REQUEST

Current Zoning: R-5 (single family residential)
 Proposed Zoning: UR-2(CD) (urban residential, conditional)

Approximately 0.17 acres located at the northeast corner of E. 17th Street and N. McDowell Street.
 (Council District 1 - Egleston)

The petition proposes to develop the site to allow five single family attached dwelling units, at a density of 29.4 units per acre.

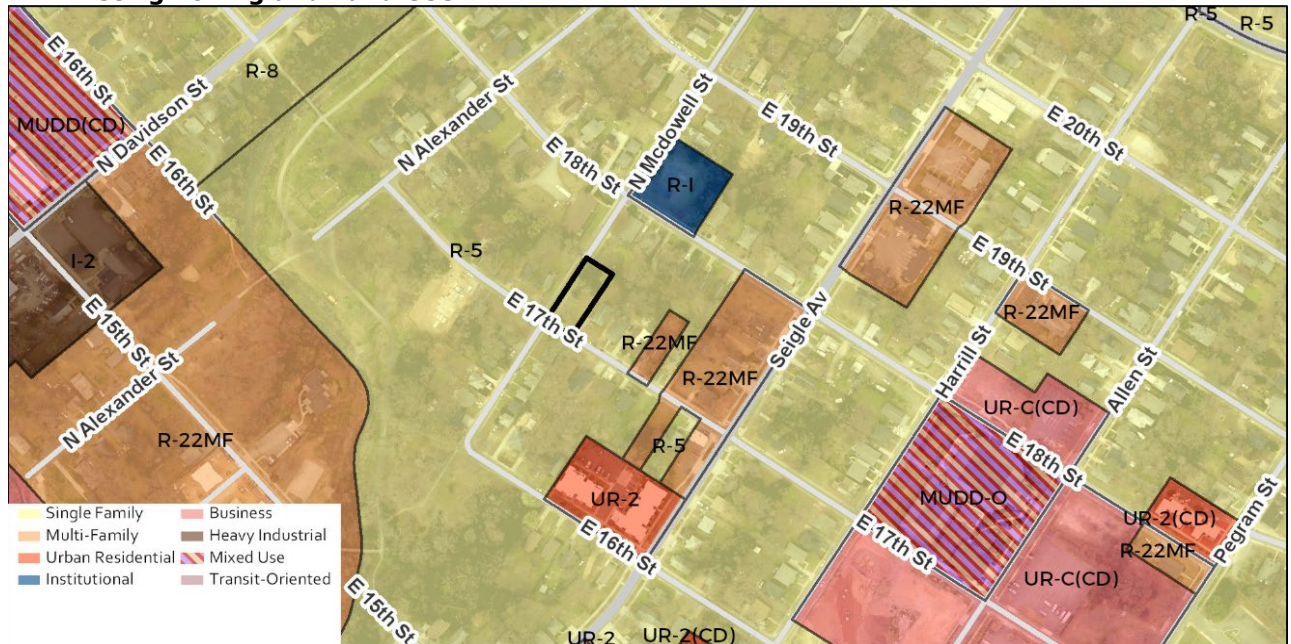
The site plan accompanying this petition contains the following provisions:

- Maximum of five single family attached dwelling units limited to 40 feet in height.
- One unit will be for-sale affordable at 80% AMI, with a 10-year restriction on resale, or shall be eligible for the in accordance with the City of Charlotte's House Charlotte program. Housing Authority's affordable housing guidelines.

- Site vehicular access via N. McDowell Street.
- Preferred building materials consisting of brick, cedar shake, wood siding, fiber cement siding, stucco, masonry and/or other material approved by the Planning Director. Permitted roof materials include asphalt shingles, composition shingles, wood shingles, tin, standing seam metal, and wood shakes.

- Minimum seven-foot sidewalk along curbside in alignment with the existing sidewalk, and an eight-foot planting strip along both E. 17th Street and N. McDowell Street. in the remaining area between the sidewalk and the property boundary. The planting strip will be increased to eight feet in width if open space is no longer required. A six-foot sidewalk along curbside and eight-foot planting strip will be provided along N. McDowell Street. In order to accommodate tree save, connections to existing sidewalk and grade of the property, the sidewalk and planting strip may be inverted, with the sidewalk located at the back of curb and the planting strip located inside of the sidewalk.

- A retaining wall may be located between the sidewalk and planting strip.
- A minimum four-foot walking space will be provided between any sidewalk obstruction and edge of curb or any adjacent retaining wall.

- Providing 429 square feet of tree save area, and 1,115 square feet of replanting area.
- Providing a site distance diagram exhibit.
